Flood Control Project Maintenance
2018 Structure Summary Report
Overall Unit and Item Ratings

San Joaquin County Flood Control and Water Conservation District

Duck Creek Diversion Weir And Control Structure

Flood Control Project Maintenance**Unit Cover Sheet****2018 Structure Inspection Results****San Joaquin County Flood Control and Water Conservation District**

Photo 1 of 1 : ST_2018_NA0017_18_12_20180625_00022.jpg

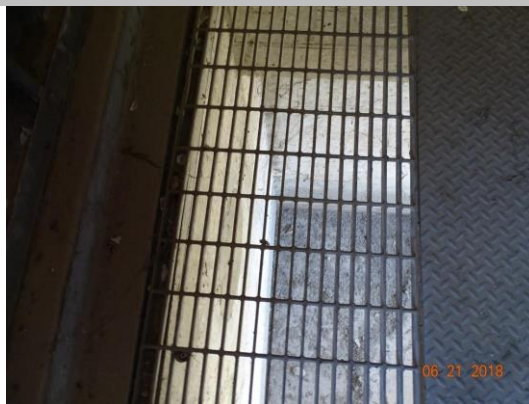
LM Start	0.00	Rating **	A	Issue No.	12
LM End	0.00	Issue Type +	Ma	Location *	
Category	Pump Stations			GPS Latitude/Longitude	
				Start	End
Item	Sumps/Wet Well			37.989633 °	37.989633 °
				-121.266933 °	-121.266933 °
DWR ID	DWR_NA0017_18_t_2012_12				
Action/Comments					
Inspector Comments: The wet well was completely dry and very little debris was present during inspection.
